# Pennsylvania Power & Light Company

SUSQUEHANNA STEAM ELECTRIC STATION  
CHUGGING LOAD DEFINITION  
ER 100450 FILE 172-08  
PLA-1097

RESPONSE TO NRC CONCERNS REGARDING THE SSES  
CHUGGING LOAD SPECIFICATION

Figure 2-5.

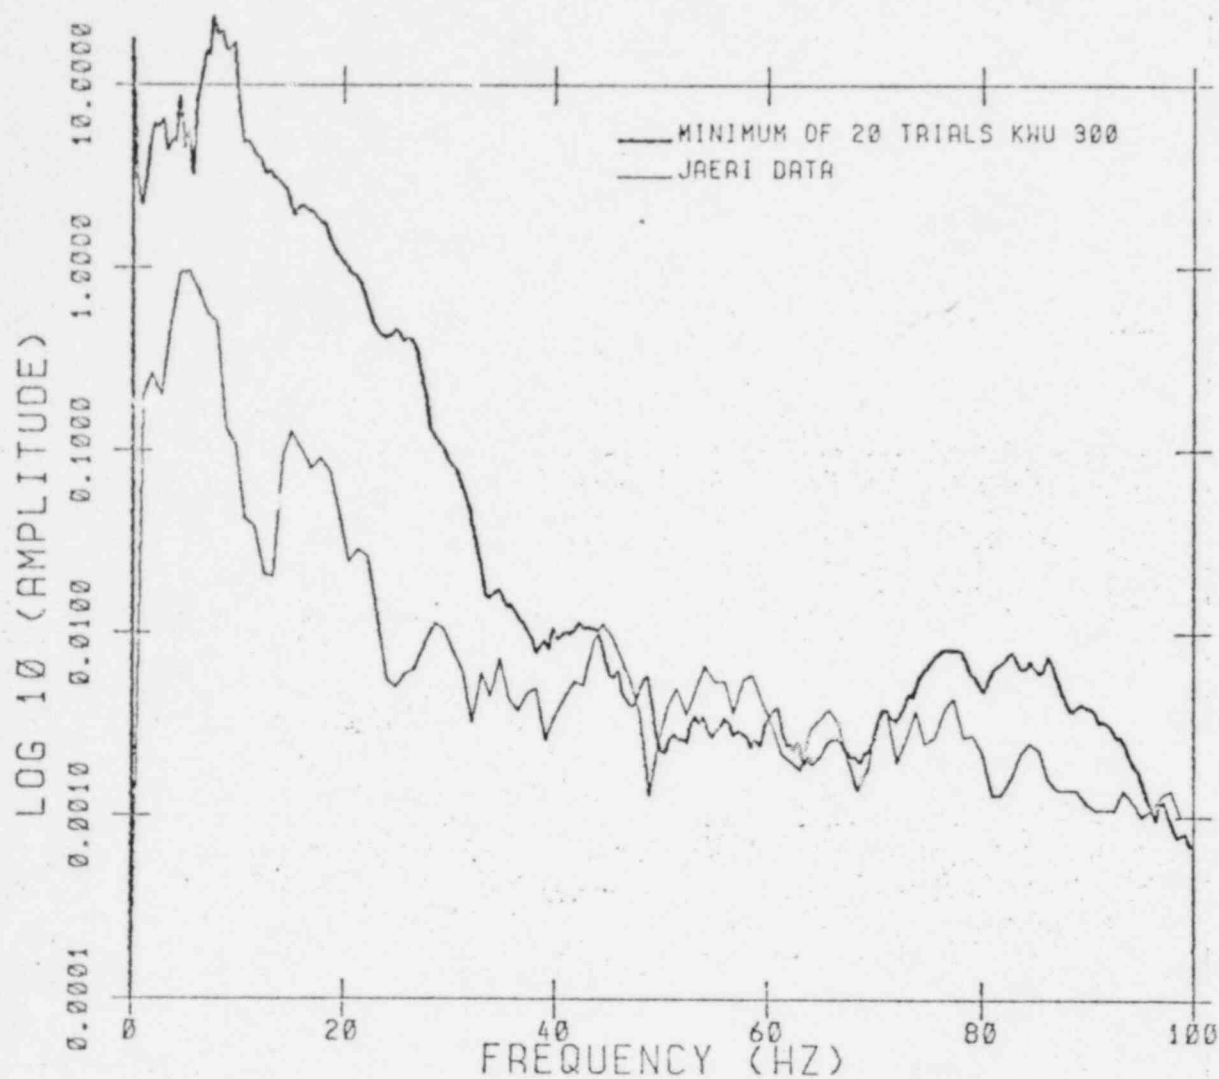
velope drop to very low levels beyond 30 Hz. Figure 2-5 shows the same data plotted on a log scale, and it is seen that in the frequency range between 40 and 60 Hz, the JAERI data envelope "pokes through" the minimum envelope by small amounts.

Figure 2-6. COMPARISON OF THE MINIMUM PSD ENVELOPE OF  
20 MIN. VAR. STS TRIALS WITH MAXIMUM PSD  
ENVELOPE OF JAERI DATA AT 1.8 M ELEVATION--  
AMPLITUDE FACTOR 1.95.

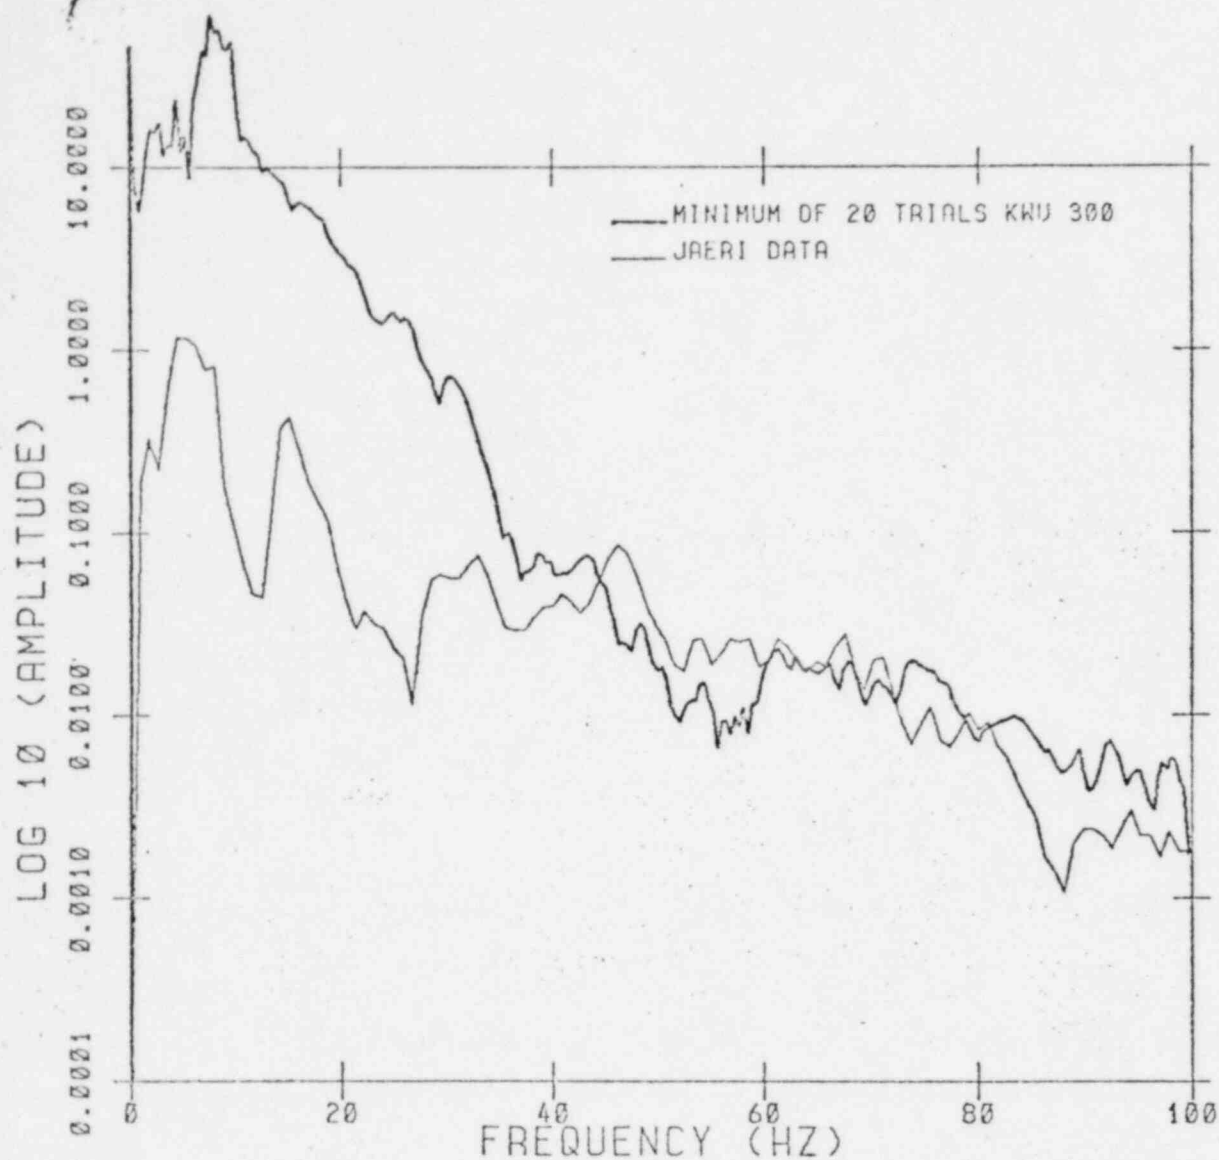
As mentioned earlier in Section 2.2, the appropriate amplitude factor for the seven vent JAERI geometry is 1.95. Comparisons are now made using the 1.95 amplitude factor. Figure 2-6 shows the comparison of the minimum envelope of 20 minimum variance STSs with the maximum JAERI data envelope at the 1.8 meter elevation. It is seen that with this amplitude factor of 1.95, the minimum variance envelope bounds the JAERI data by substantial margins everywhere except for some small "poke throughs" in the frequency range between 45 and 80 Hz. Figure 2-7 shows a similar comparison at the 3.6 meter elevation and at this elevation, the minimum envelope of the 20 minimum variance STSs bounds the JAERI data at all frequencies.

Figure 2-8. COMPARISON OF THE MINIMUM PRS ENVELOPE FOR THE 20 MIN. VAR. STS TRIALS WITH THE MAXIMUM PRS ENVELOPE OF THE JAERI DATA--AMPLITUDE FACTOR 1.3, DAMPING 4%.

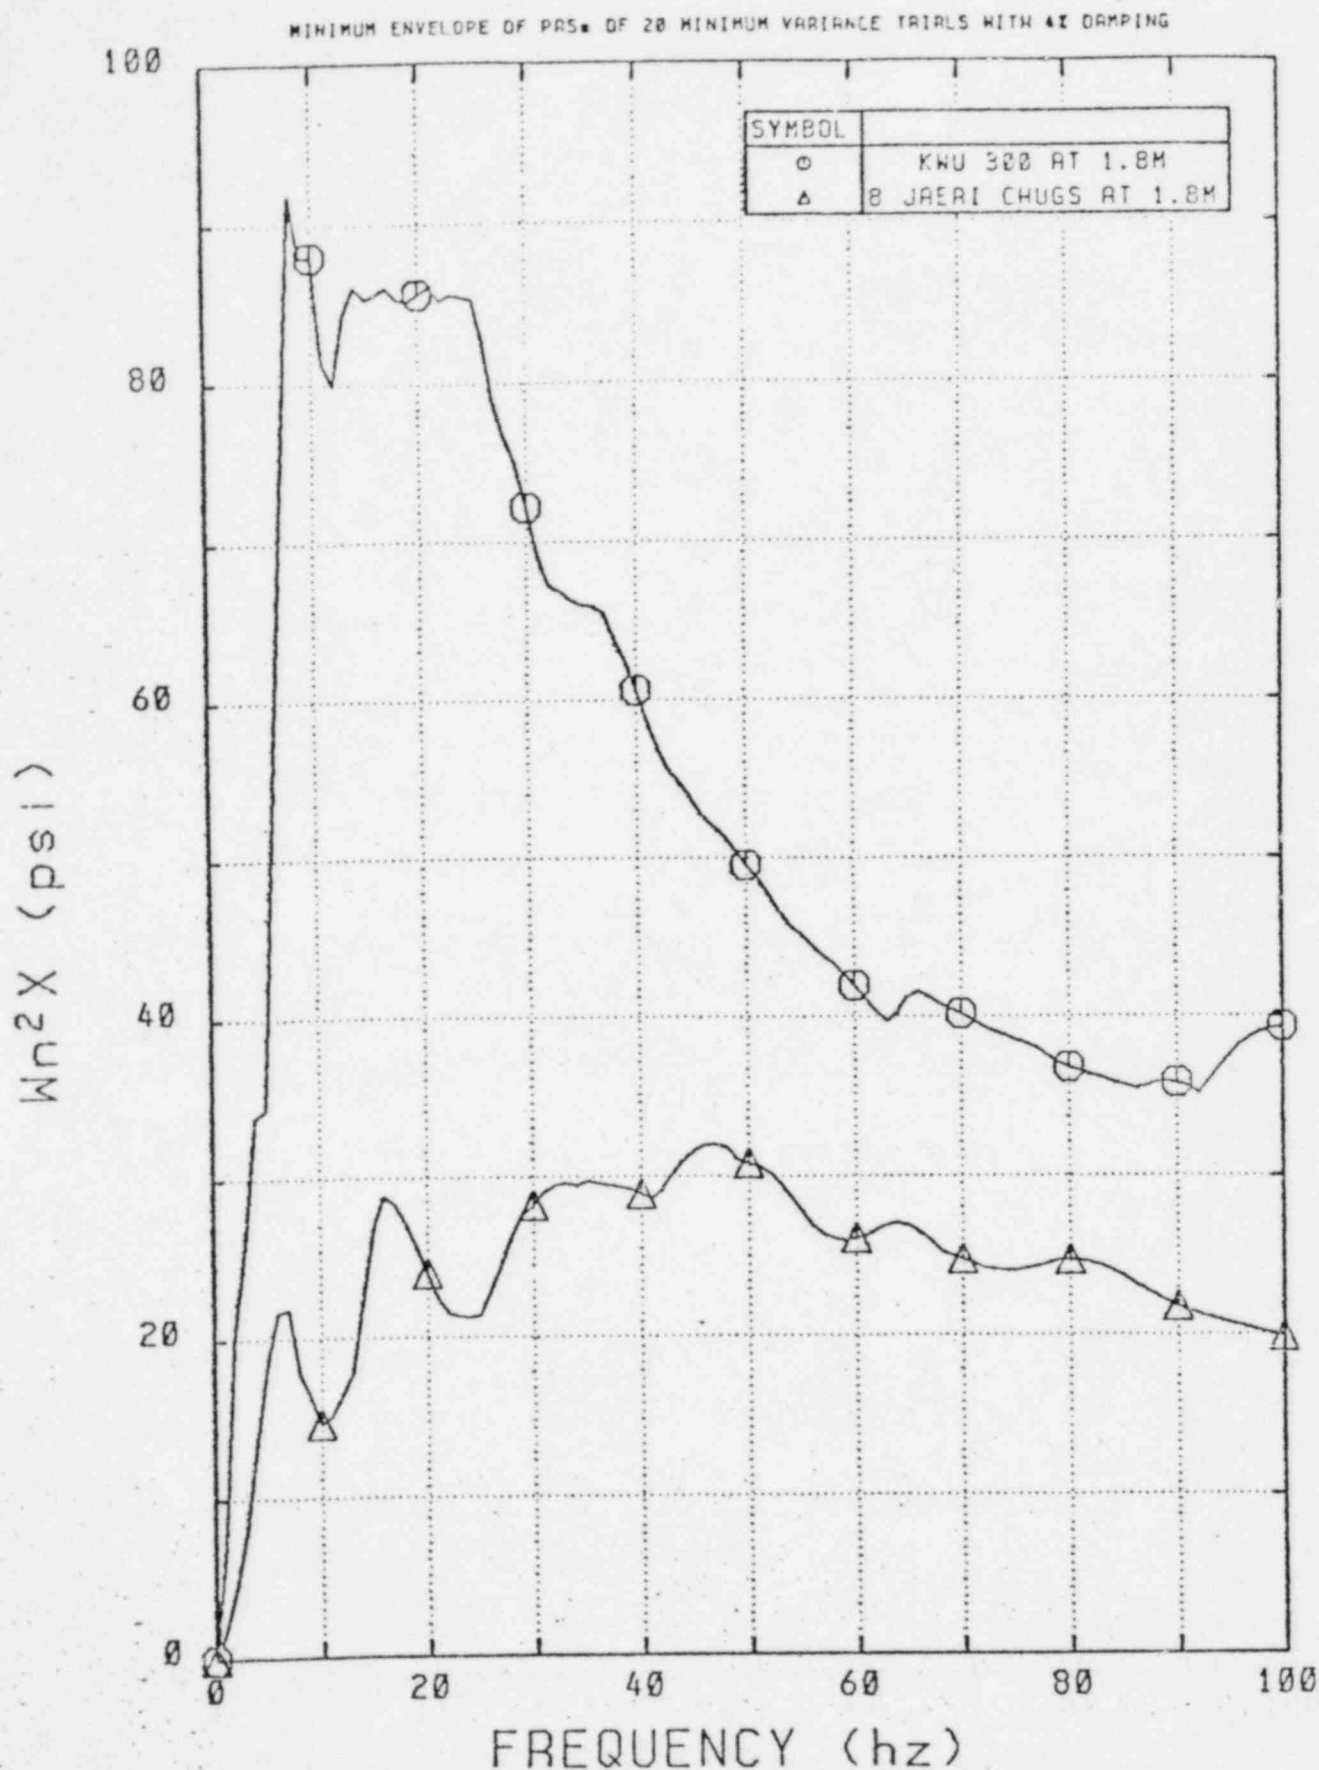
The comparison of the minimum PRS envelope for the 20 minimum variance STSs with the maximum PRS envelope of the JAERI data at the 1.8 meter elevation is shown in figure 2-8. For the PRSs shown in this figure, the SSES amplitude factor of 1.3 was used with a damping value 4%. It is clear from this figure that the minimum envelope of the 20 minimum variance STSs bounds the maximum PRS envelope of the JAERI data throughout the frequency range between 0-100 Hz. Figure 2-9 shows the PRS comparisons for an amplitude of 1.35, and a 4% damping. Again this figure shows that the minimum envelope of the 20 minimum variance trials bounds the maximum JAERI data envelope by significant margins across the entire frequency range.

Figure 2-10. COMPARISON OF THE MINIMUM PRS ENVELOPE FOR THE 20 MIN. VAR. STS TRIALS WITH THE MAXIMUM PRS ENVELOPE OF THE JAERI DATA--AMPLITUDE FACTOR 1.3 DAMPING 7%.

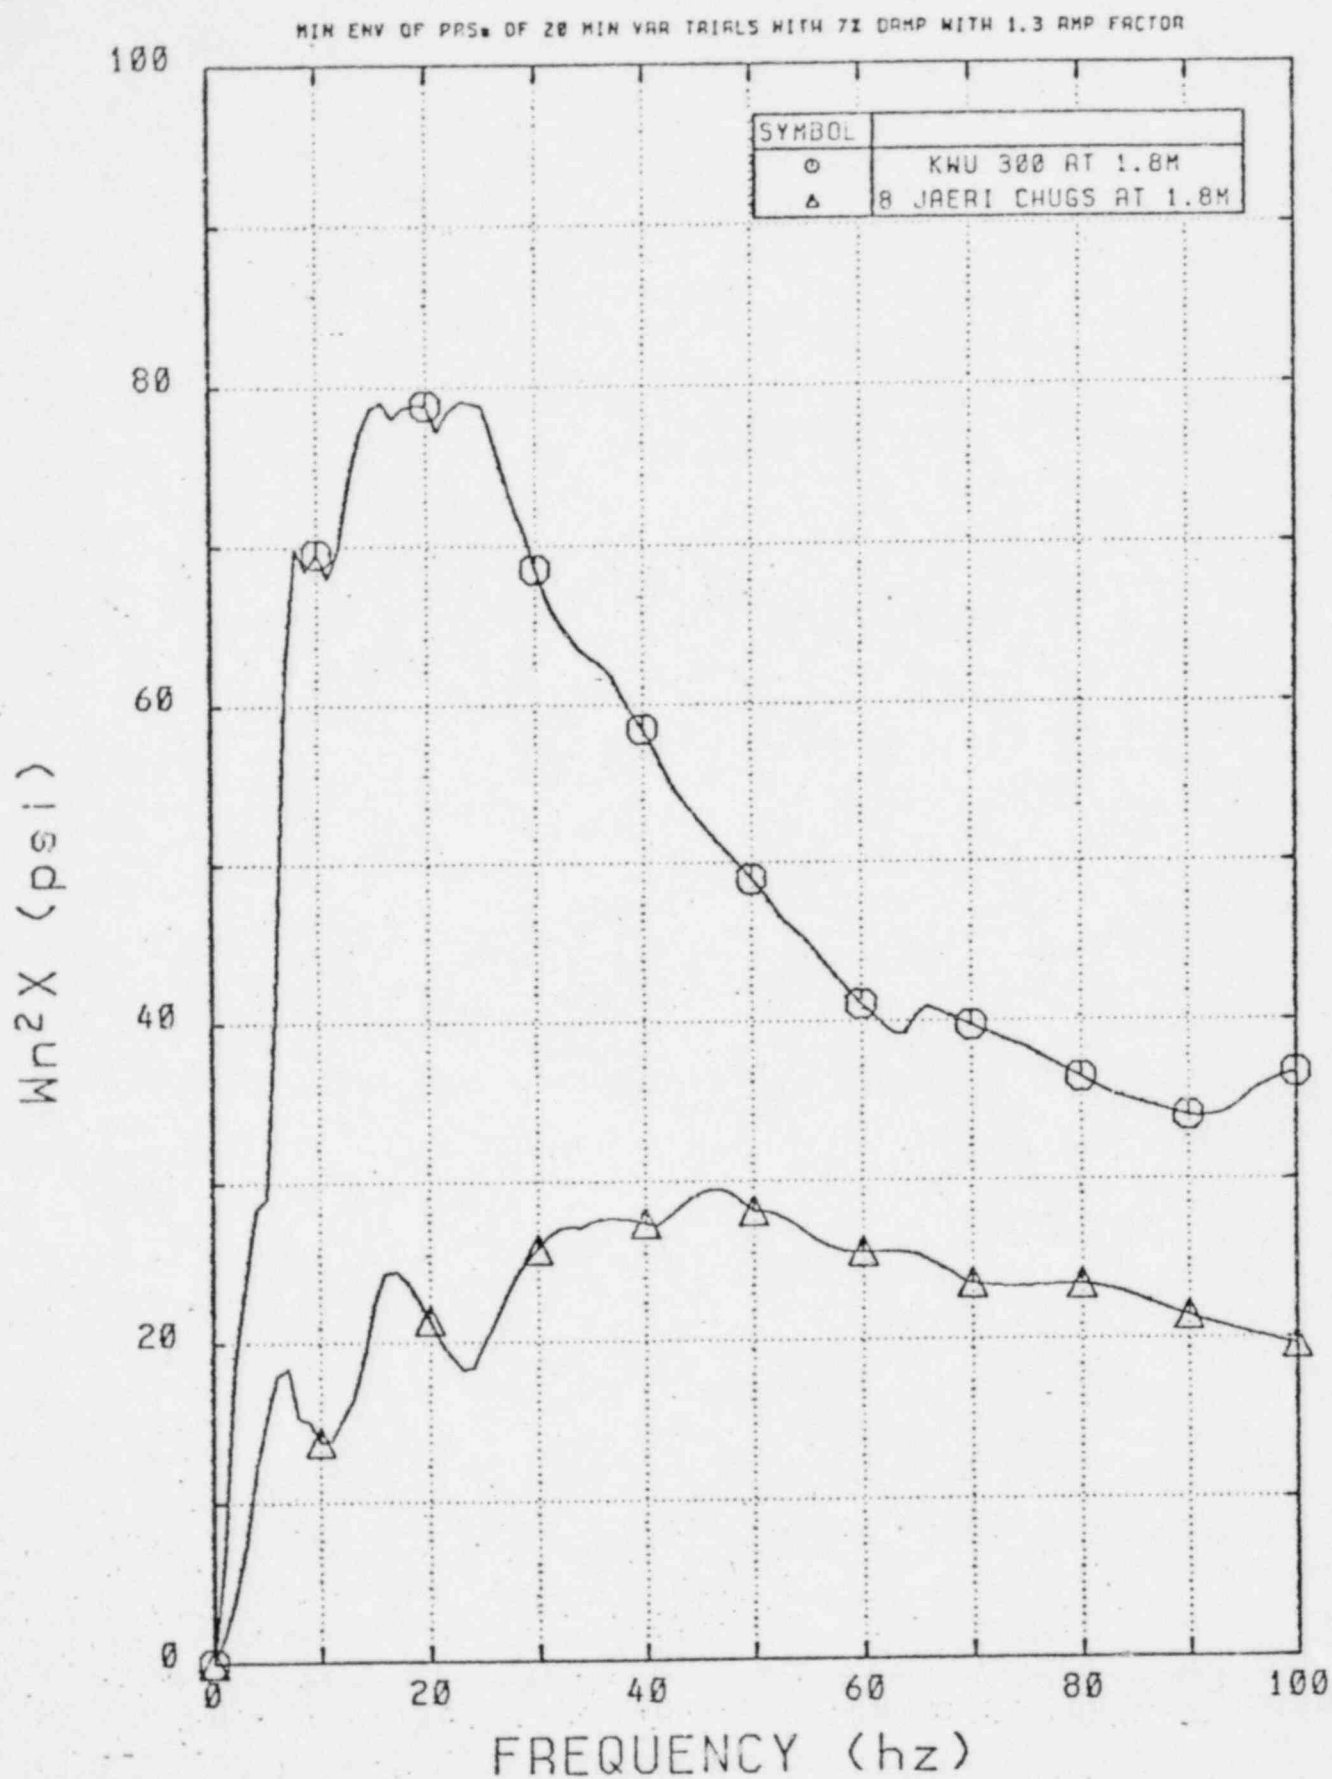
Finally, Figures 2-10 and 2-11 show the PRS envelope comparisons for the 7% damping case with amplitude factors of 1.3 and 1.95 respectively. From these figures it is again seen that the minimum PRS envelope of the 20 minimum variance STSs bounds the maximum JAERI data PRS envelope by a substantial margin throughout the frequency range.
